UNITED STATES PATENT AND TRADEMARK OFFICE

APPLICATION NO.	FILING DATE	FIRST NAMED INVENTOR	ATTORNEY DOCKET NO.	CONFIRMATION NO.
10/733,213	12/11/2003	George S. Pabis	12093/929	7999
26646	7590	05/02/2006	EXAMINER	
KENYON & KENYON LLP ONE BROADWAY NEW YORK, NY 10004			GREENE, DANIEL LAWSON	
			ART UNIT	PAPER NUMBER
			3663

Office Action Summary

DETAILED ACTION

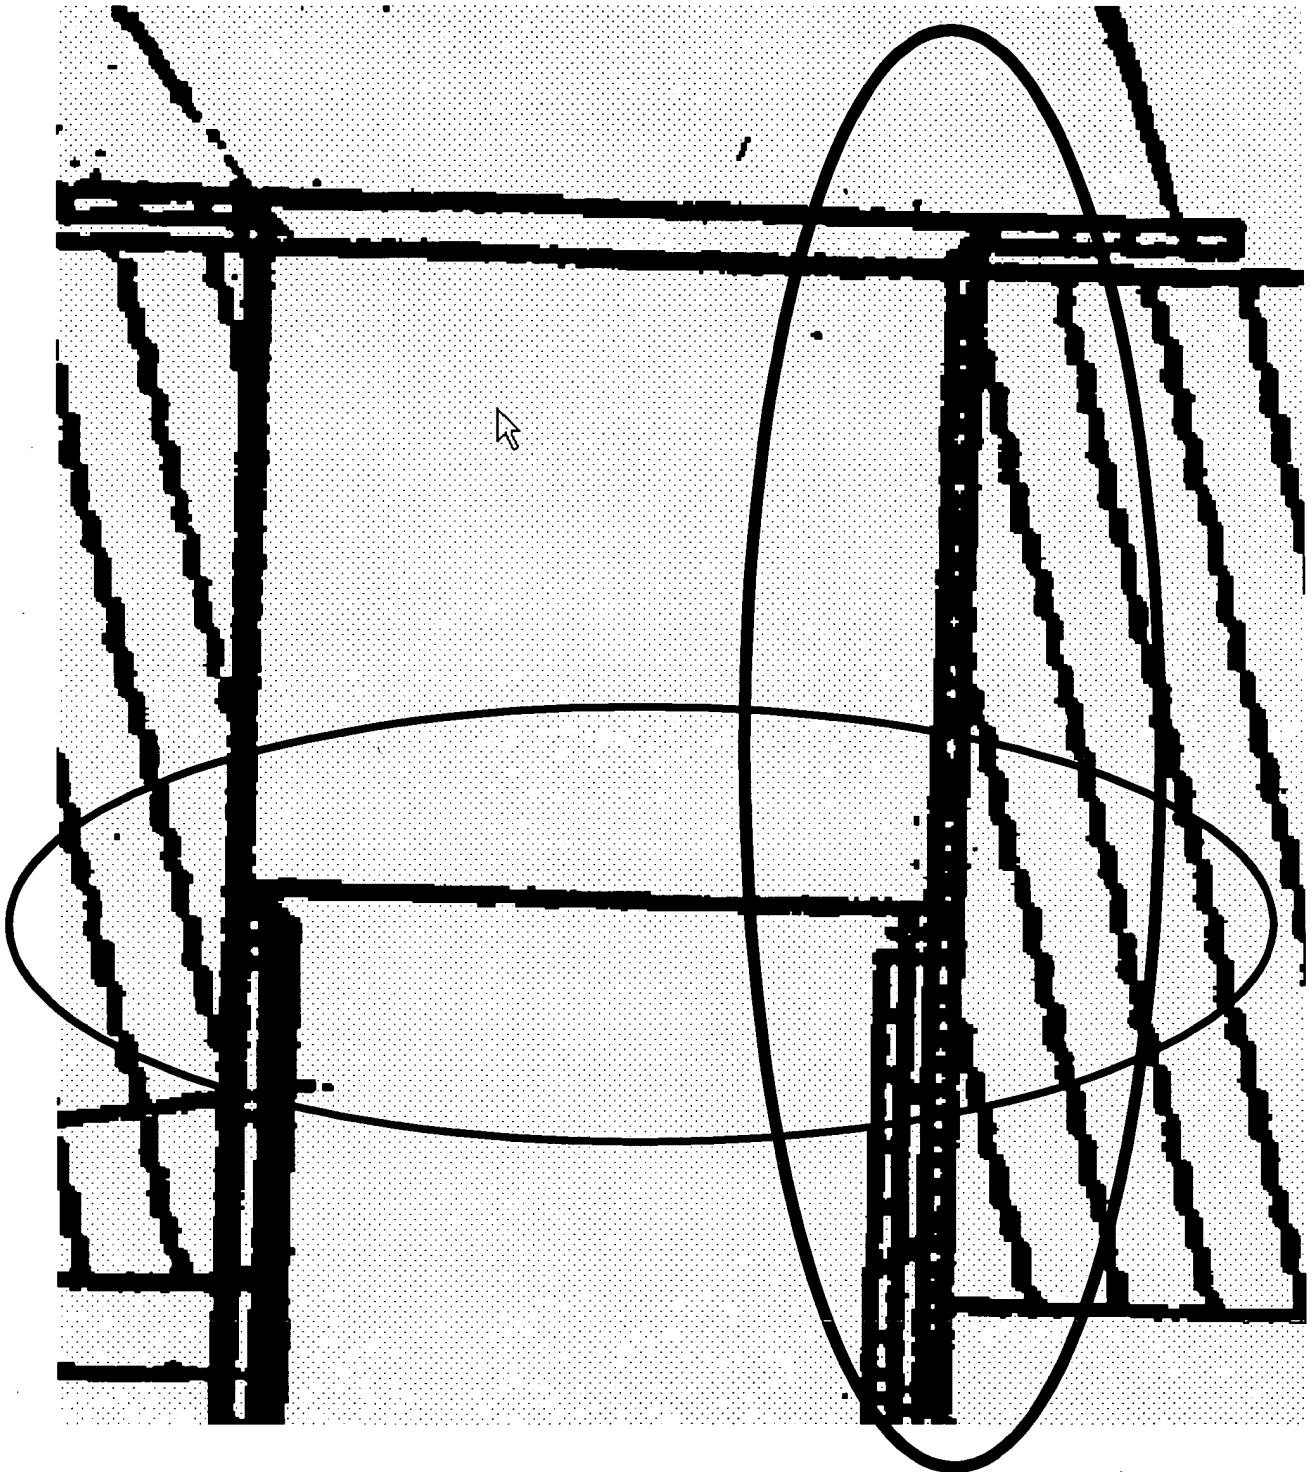
2. The drawings are objected to under 37 CFR 1.83(a) because they fail to show the repair sleeve having a lapped edge as described in the specification as

filed, page 5 lines 22+. As illustrated in the exploded portion of Figure 2 below, Figure 2 does NOT indicate that shaft 72 continues past the horizontal line encompassed by the horizontal oval below. Figure 2 appears to show that it is actually guide thimble sleeve (68) that is lapped over the edge.

Any structural detail that is essential for a proper understanding of the disclosed invention should be shown in the drawing. MPEP § 608.02(d). Corrected drawing
